New Meters, Allocations & Expansion of Services Committee Agenda

Review of Application for Will Serve Letter

New 748 sqft ADU for Property with Existing Meter at 165 S. Alvarado.

A-1.01

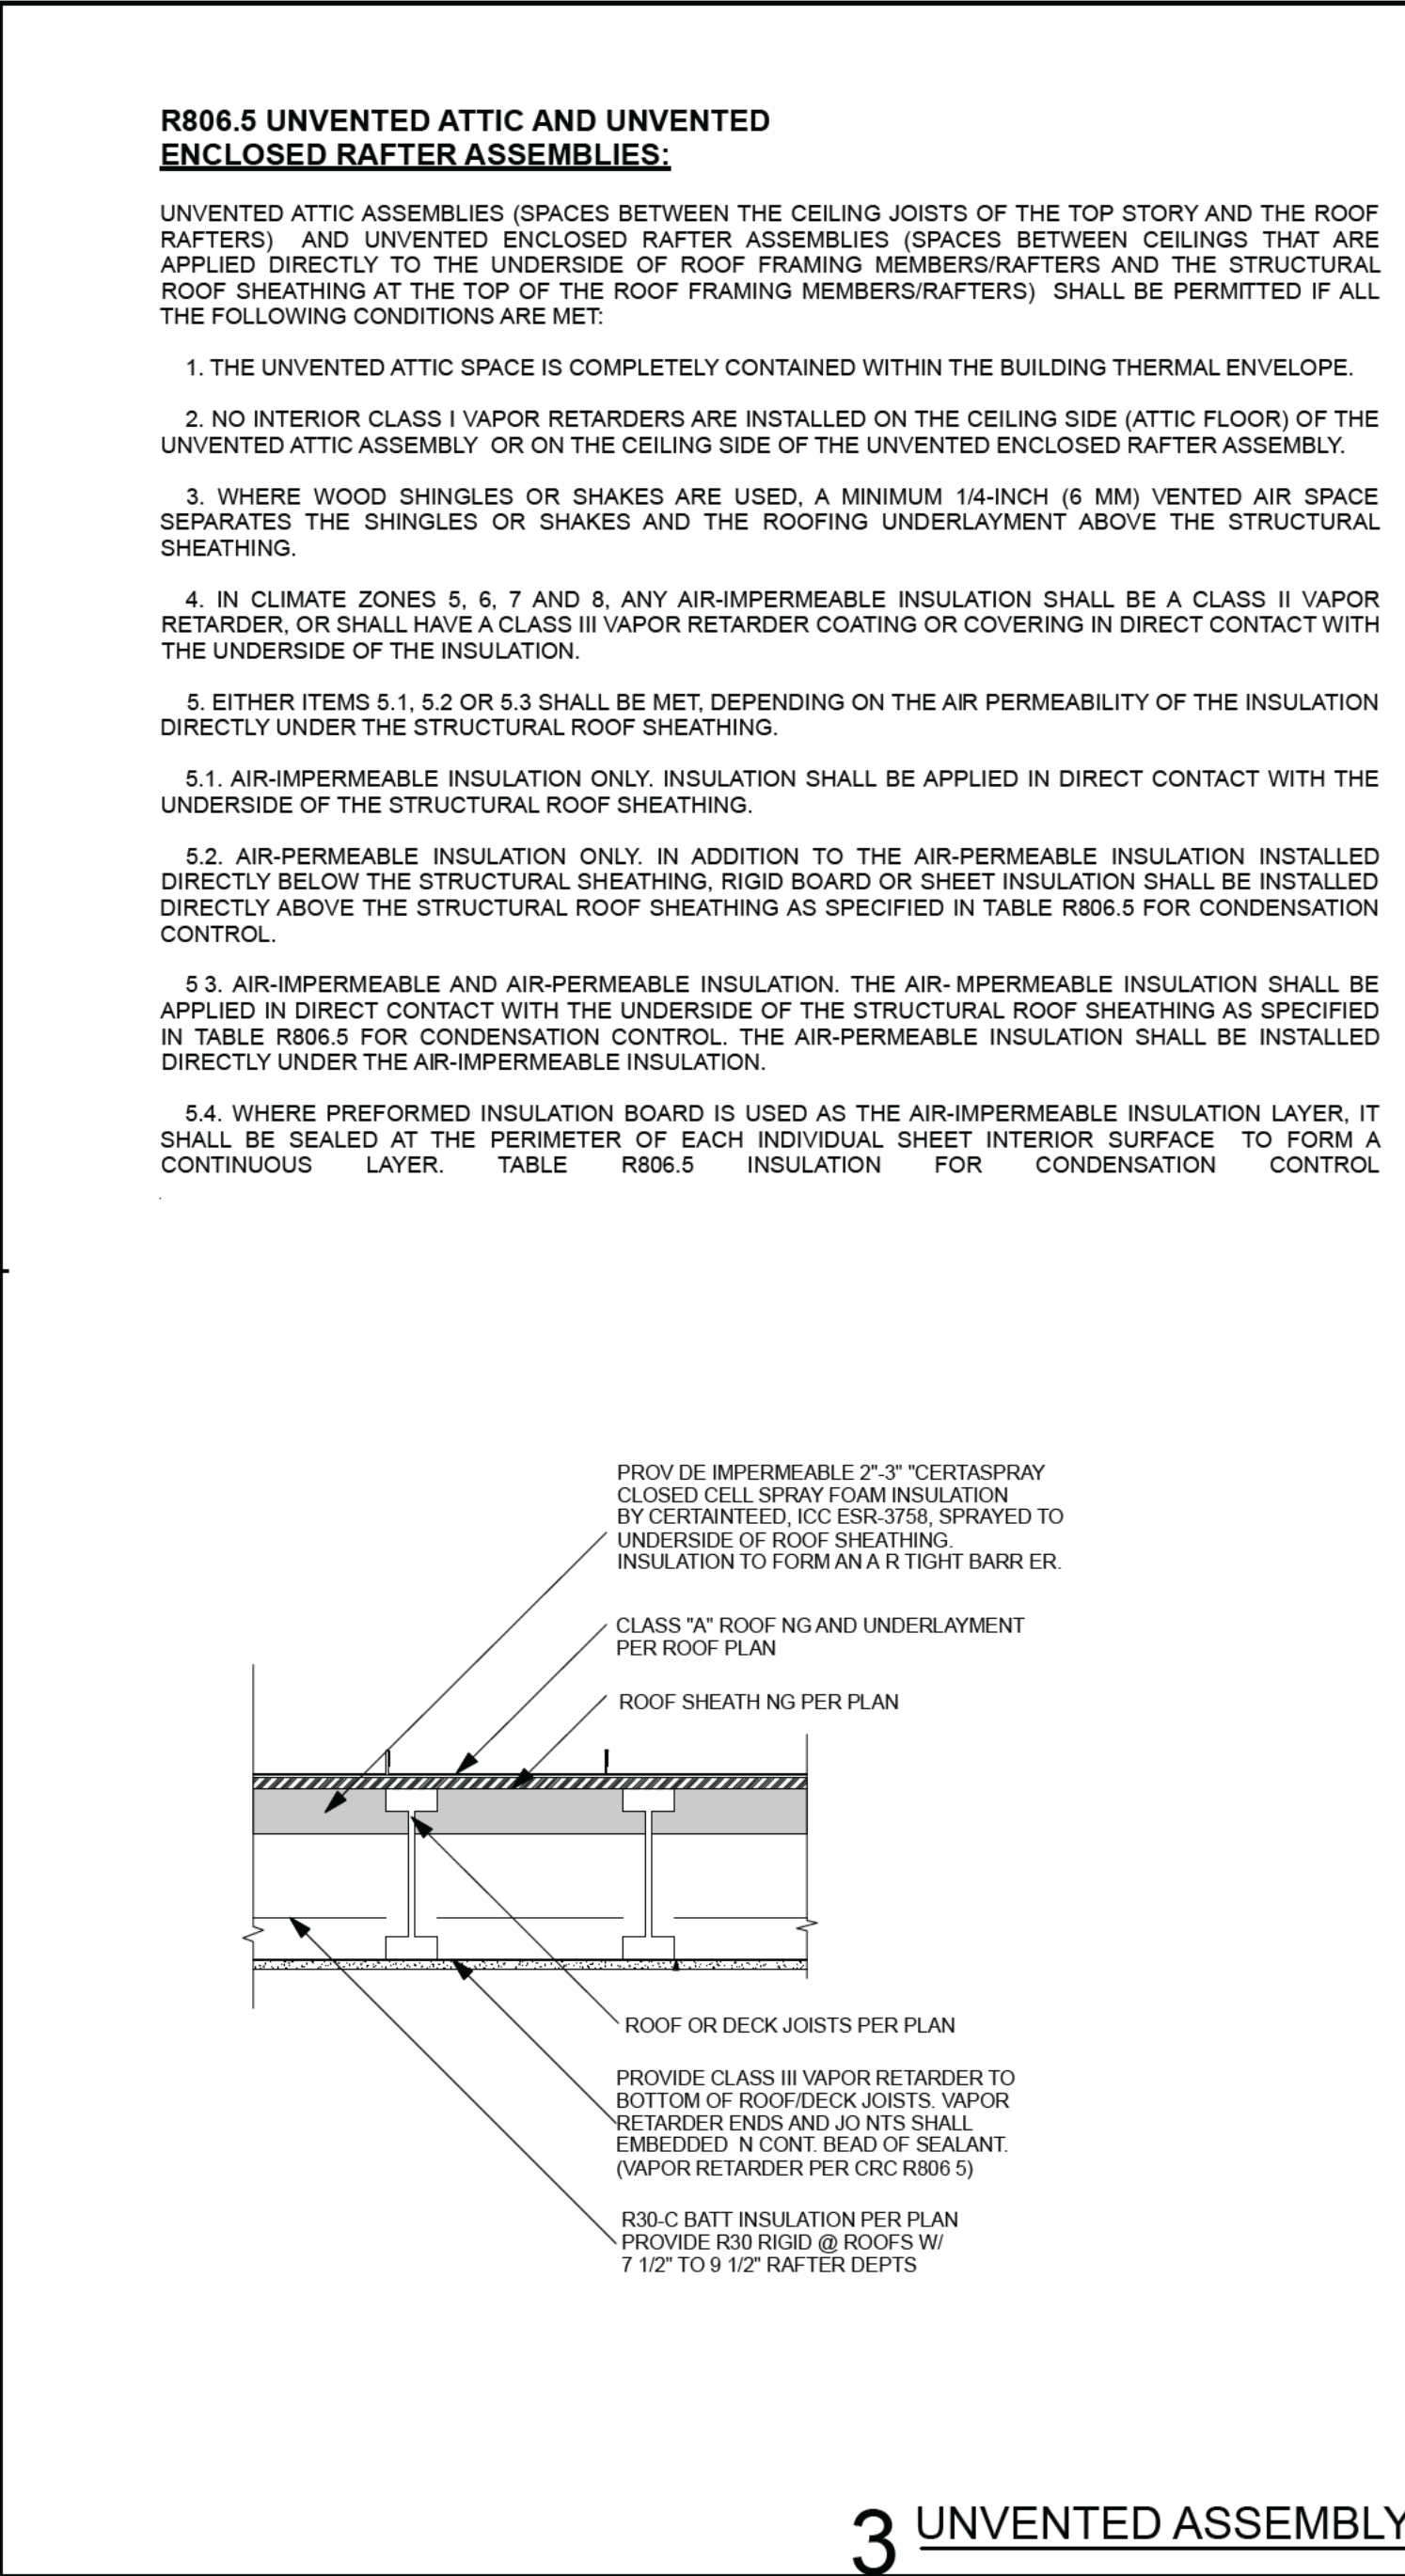
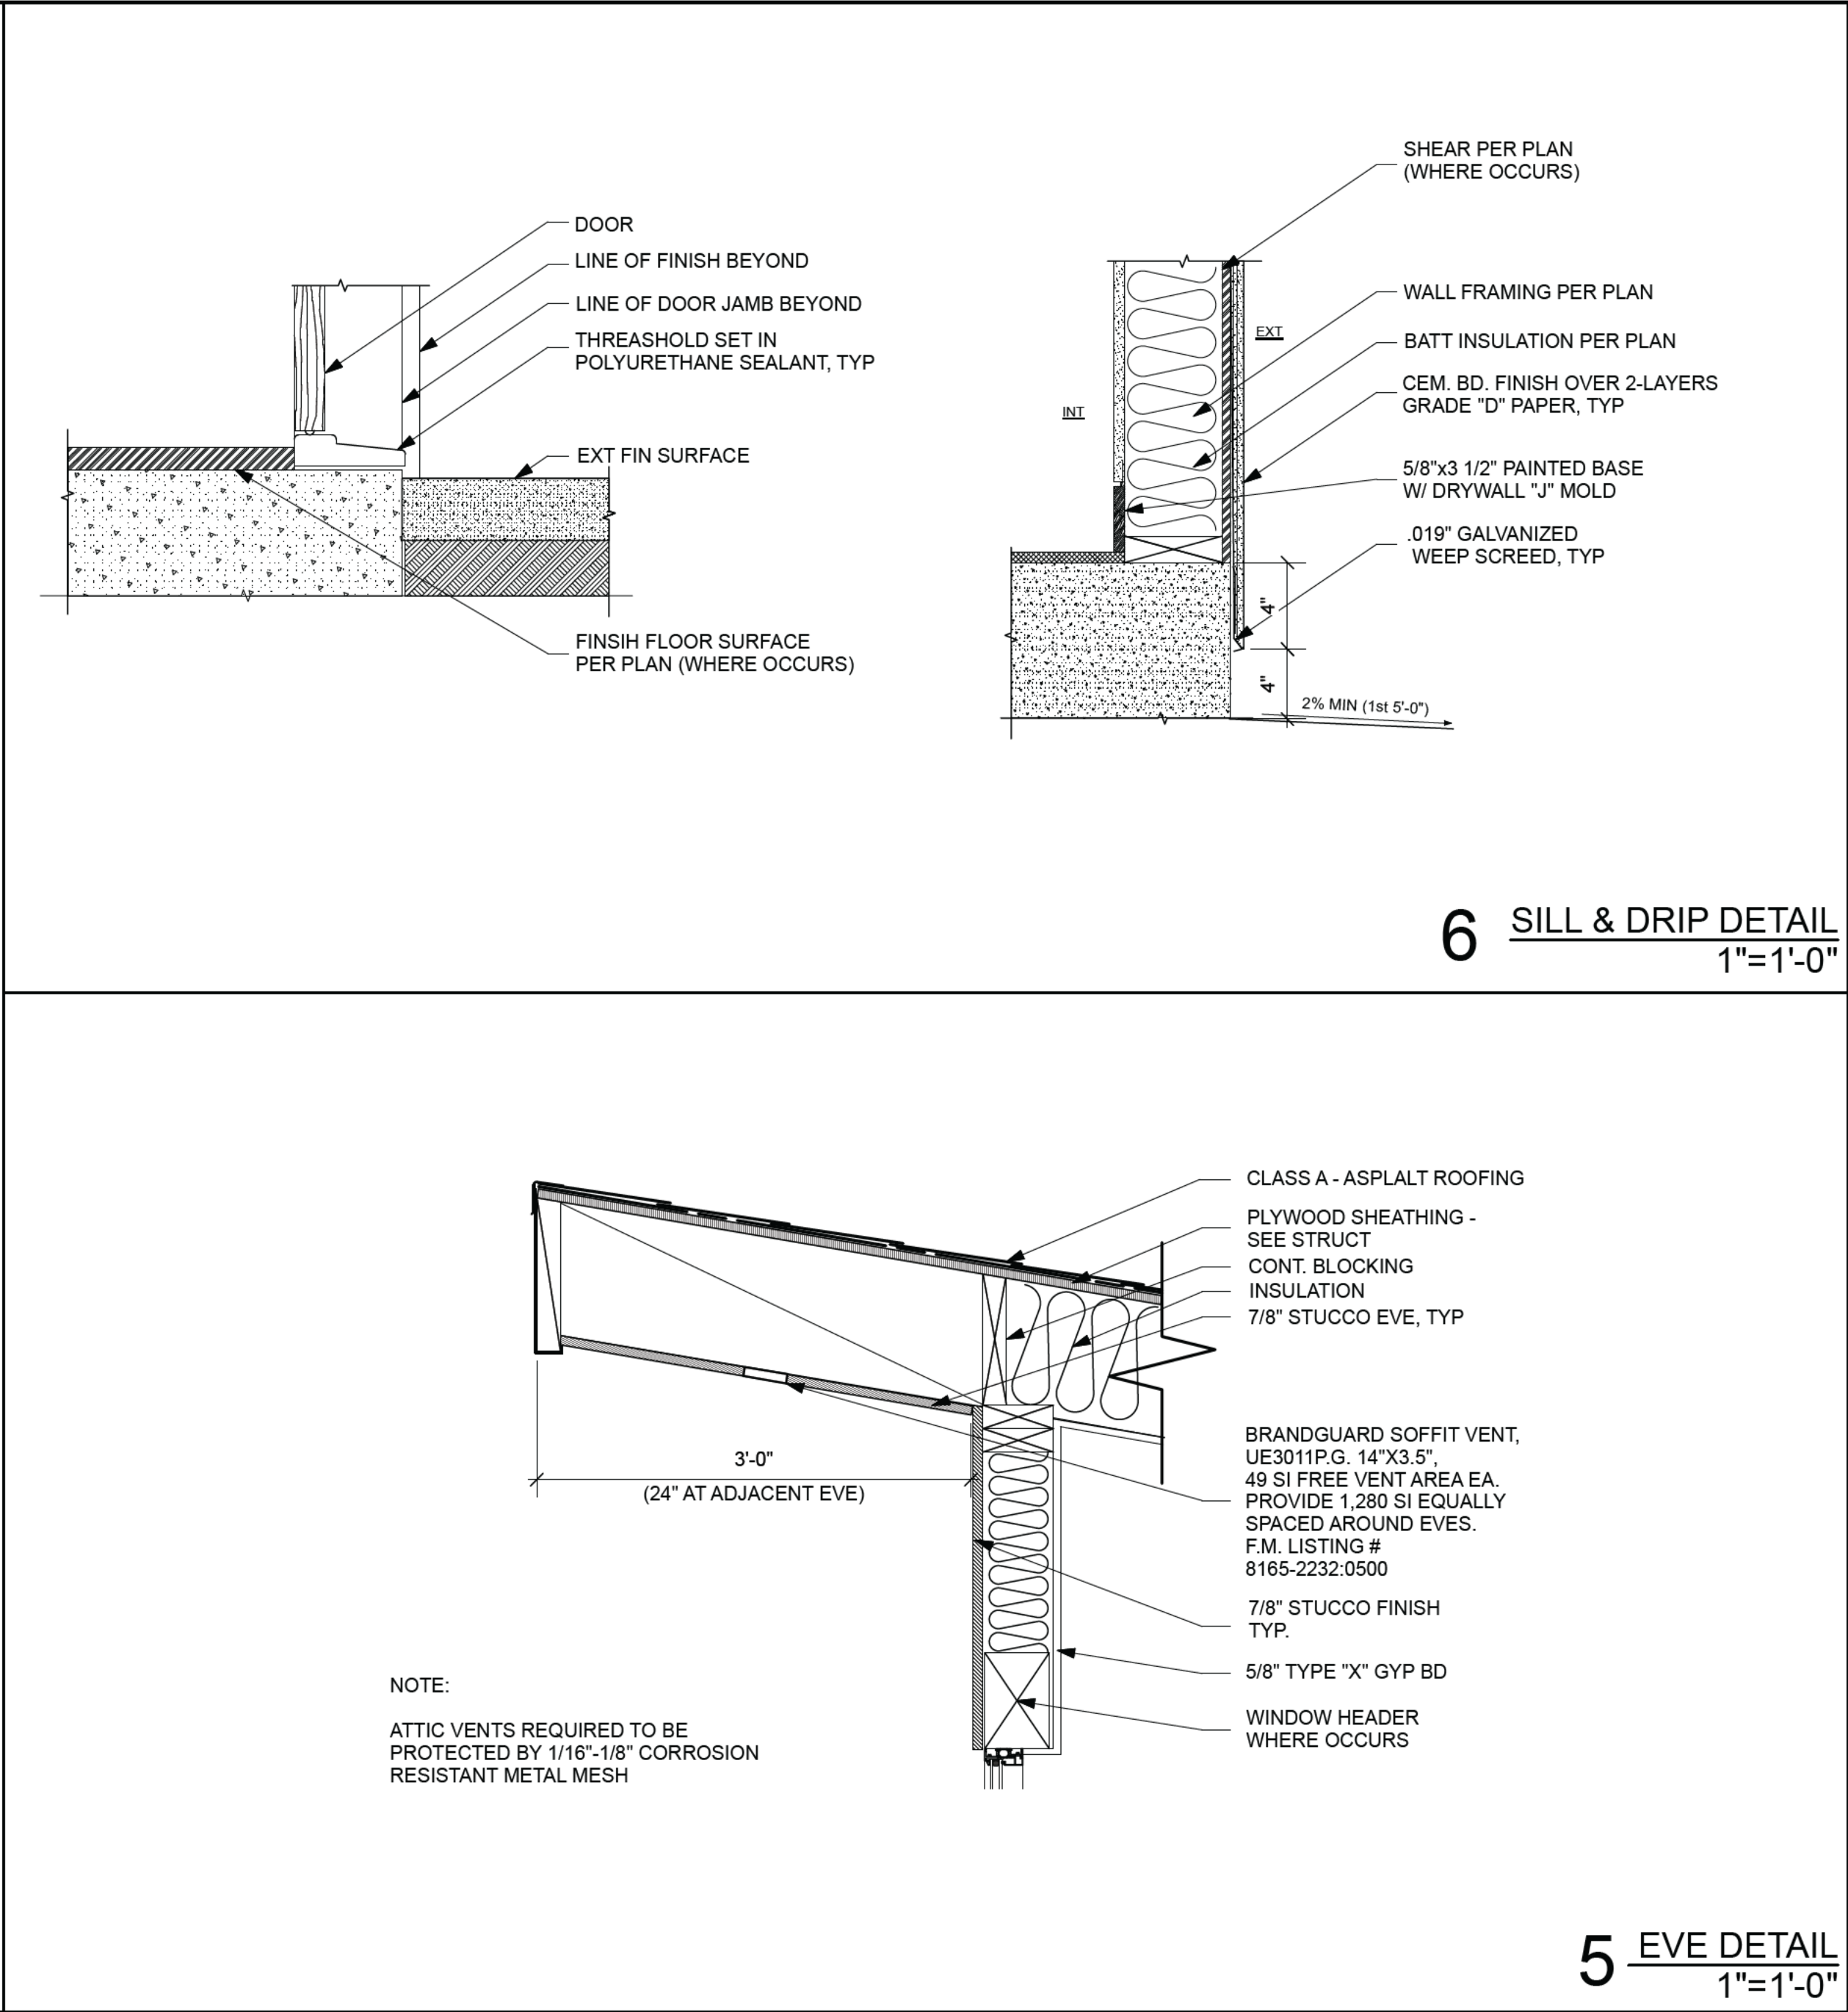
The proposed project consists of adding a new 748 sqft, 2-bedroom + 2 bathroom ADU. The applicant provided a detailed site plan showing the location of the proposed structure.

- *Recommend purchase of at least 36 HCF from Casitas MWD to support ADU and 15 HCF for outside irrigation.*
- Letter applies only to the proposed ADU as described in the applicant-provided preliminary site plan with the filing date of 8-15-2023.
- **There will be no increase in the total (fixed plus variable) water allocation assigned to the meter Will Serve Letter will expire after 1 year.**
